RE: Planning Consultation Request for case ref: 25/1072 (34 High Street N...

Re: REPLACEMENT ADVERTISEMENTS TO BUILDING, 1NO AV SCREEN TO WINDOW (INSTALLED INTERNALLY), NEW WINDOW MANIFESTATION AND NEW FINISHES INTERNALLY

NatWest 1402.0x01
Halo Illuminated Letters_General Assembly
FOR QUOTATION PURPOSES ONLY

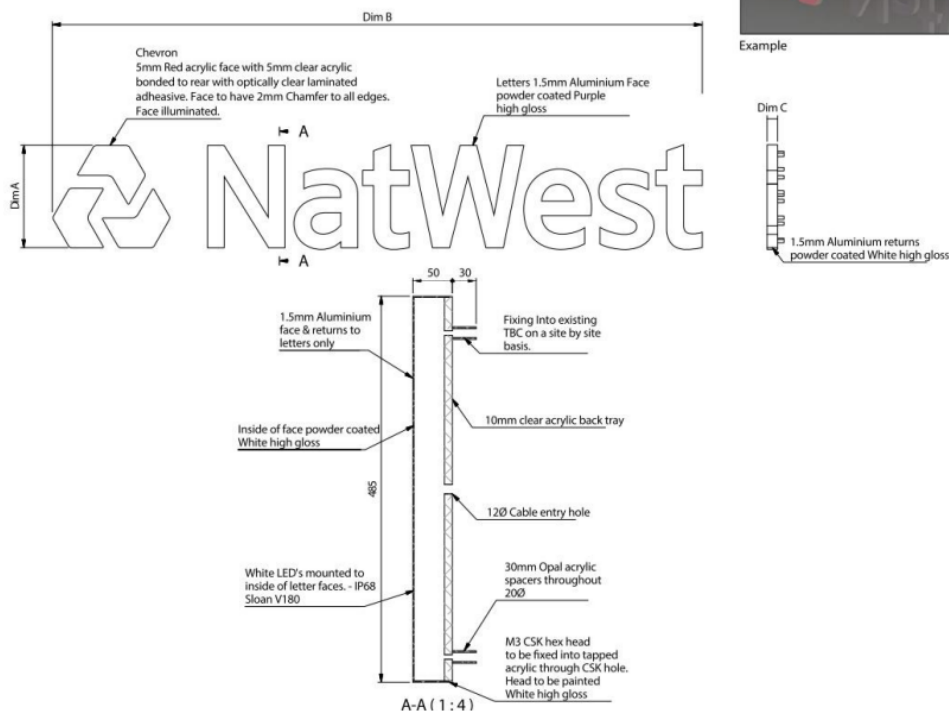
As proposed, both the drawing 'Fascia Signage – Heritage' and the accompanying 'PLANNING/HERITAGE STATEMENT' are unclear on the proposed form of the new. The latter simply stating that: "As noted in the shopfront SPD document, the fascia signage is kept to a minimum."

I would suggest that we need more details, to ensure that the new will remain a halo-illuminated and pin-mounted design. Details should also be provided for making-good on redundant penetrations within the stonework, to ensure that the frieze does not become peppered with holes over time. To this regard, I would suggest that all redundant fixings are removed and all redundant

holes are filled with a feebly hydraulic (NHL2) mortar of appropriate colour to match the 'orange' Bath stone.

Hanging/Projecting Signage

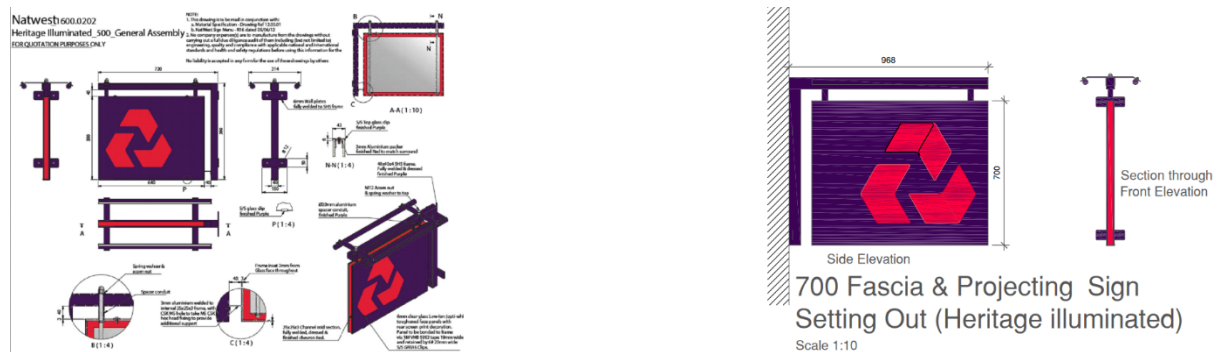
Existing projecting/hanging signage to this richly decorative GII Listed building was approved under applications 14/1166 & 14/1167. As existing, they are externally illuminated (see below). I am unclear on the precise details for the proposed and would note that internally illuminated projecting signs are contrary to our Shopfronts SPG. The simplest approach here would be to replace only the signage itself, retaining existing brackets and associated lighting. Please seek clarification.
